BAR 18-06-02
714 Locust Avenue
Tax Parcel 510069000
Front Porch, Owner/ Rashard Dacus
Applicant/ James Robertson (Robertson Renovations)
Porch replacement and construct canopy

**CITY OF CHARLOTTESVILLE
BOARD OF ARCHITECTURAL REVIEW
STAFF REPORT
June 19, 2018**

BAR 18-06-02

Porch replacement and construct canopy

**Proposed Modifications to
714 Locust Ave, Charlottesville**

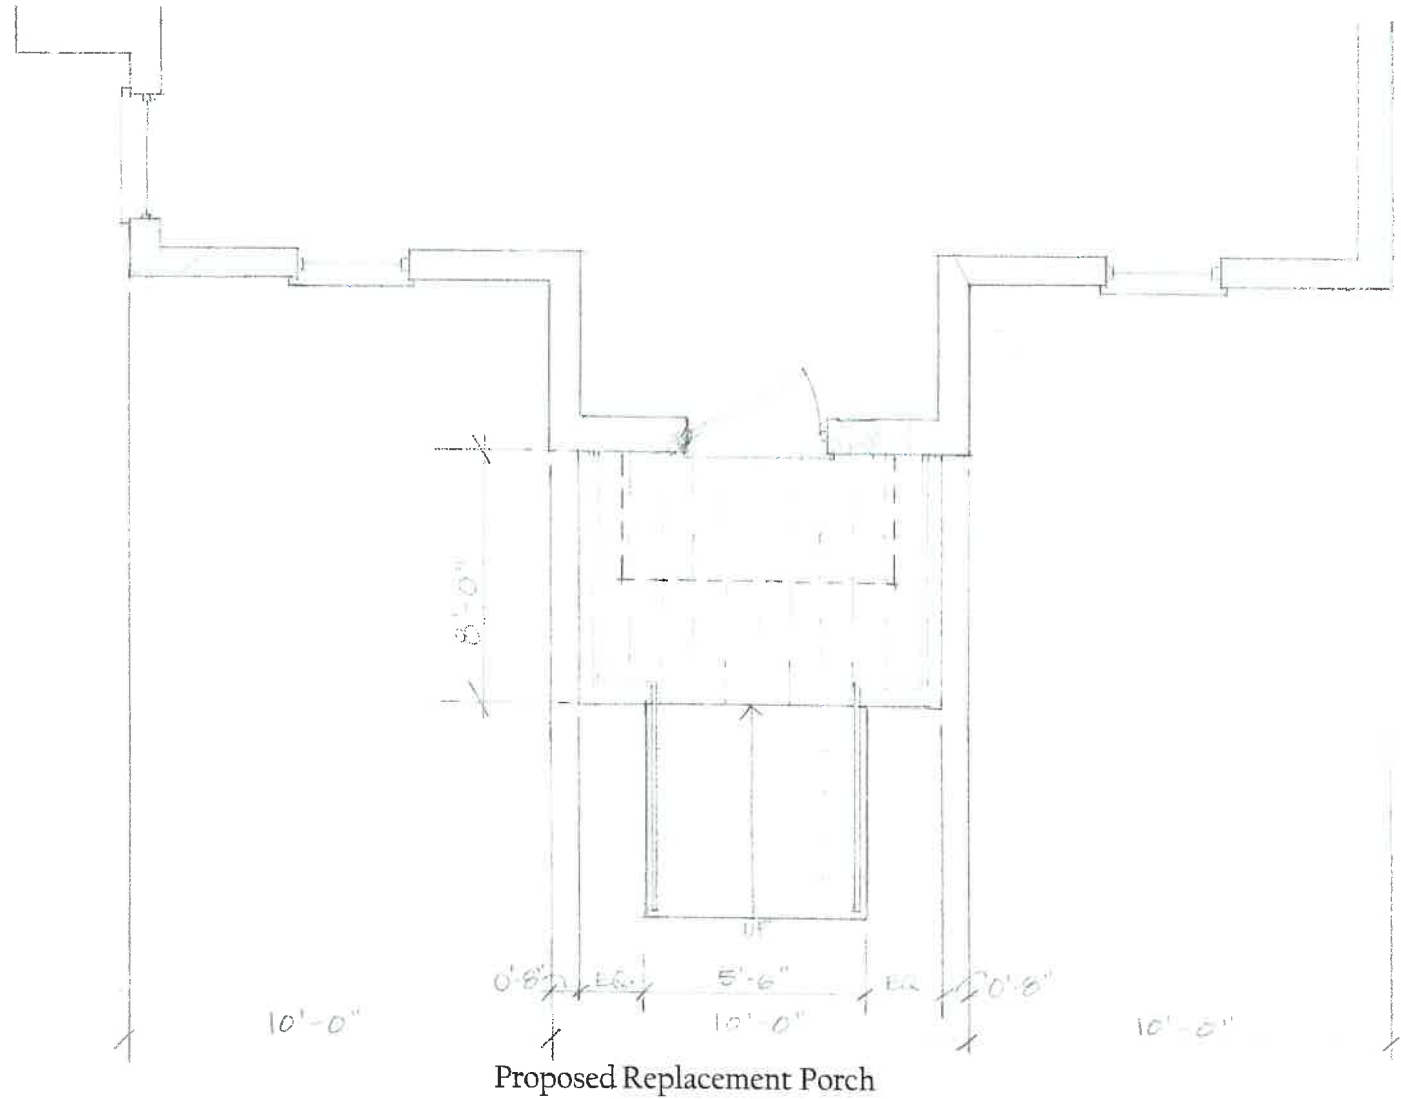
The BAR should discuss the improvements in design and concept since previous submission to BAR, but staff recommends the discussion of whether the porch addition impacts the existing architectural form and integrity of building.

Staff finds that the walkway modifications are appropriate.

Motion: Schwarz moved having considered the standards set forth within the City Code, including Historic Conservation District Guidelines for New Construction and Additions, I move to find that the proposed front porch and canopy satisfy the BAR's criteria and are compatible with this property and other properties in the Martha Jefferson Historic Conservation District, and that the BAR approves the application as submitted. Balut seconded. Approved (7-0.)
